U.S. NUCLEAR REGULATORY COMMISSION
FINAL SAFETY EVALUATION BY THE OFFICE OF NUCLEAR REACTOR REGULATION
FOR WESTINGHOUSE ELECTRIC COMPANY
TOPICAL REPORTS WCAP-17503-P/WCAP-17503-NP, REVISION 1,
“WESTINGHOUSE GENERIC SETPOINT CONTROL PROGRAM RECOMMENDATIONS,”
AND WCAP-17504-P/WCAP-17504-NP, REVISION 1,
“WESTINGHOUSE GENERIC SETPOINT METHODOLOGY”
PROJECT NO. 700

of these terms among one another is illustrated in Figure 3-1 of WCAP-17504-P/WCAP-17504-NP, Revision 1, reproduced below.

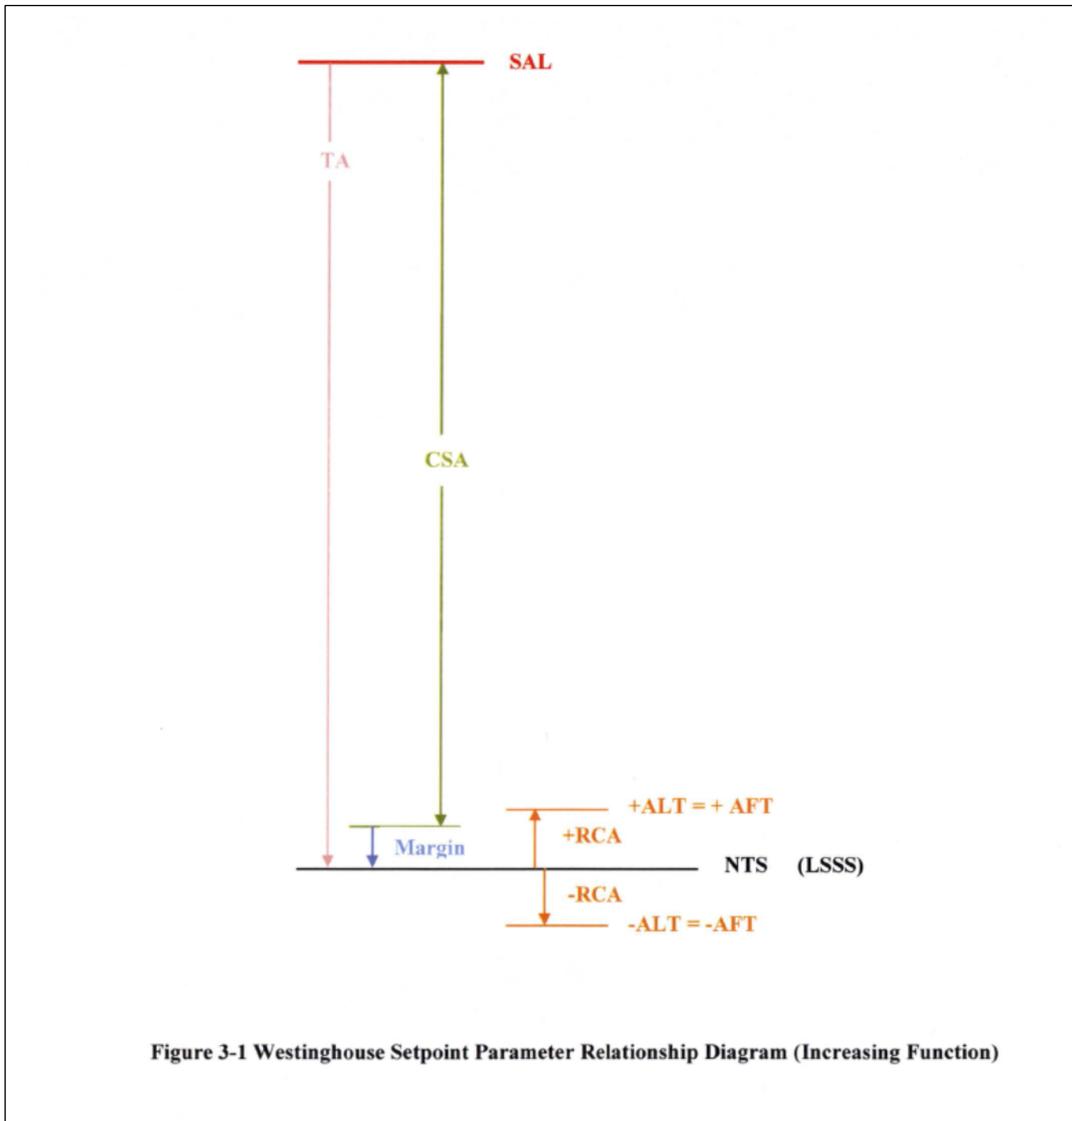
The NRC staff finds that WCAP-17504-P/WCAP-17504-NP, Revision 1, adequately describes the important relationships among Safety Limit, Analytical Limit, Limiting Trip Setpoint, Allowable Value, Setpoint, Acceptable AFT Band, Acceptable ALT Band, and Setting Tolerance. Based on the discussion of terms and relationships presented in the WCAP-17504-P/WCAP-17504-NP, Revision 1, and the sample calculations, tables, and figures presented in WCAP-17504-P/WCAP-17504-NP, Revision 1, the NRC staff finds that the Westinghouse setpoint methodology demonstrates that the correct relationships between the SL, AL, NTSP, AFT, and ALT will be ensured, that the basis for the NTS is correct, and that the requirements of GDC 13 and 20 are met.

Therefore, the WSM described in the WCAP-17504-P/WCAP-17504-NP, Revision 1, uses double-sided evaluation acceptance criteria bands. Figure 3-1 (above) and the relationships described above illustrate how the operability of the instrument loop is evaluated. Exceeding the AFT in either high or low direction may indicate degraded performance and inability of the instrument channel to meet its intended function. Not being able to reset the setpoint to within the ALT at the conclusion of a channel calibration process also may indicate degraded performance and inability of the instrument channel to meet its intended function.
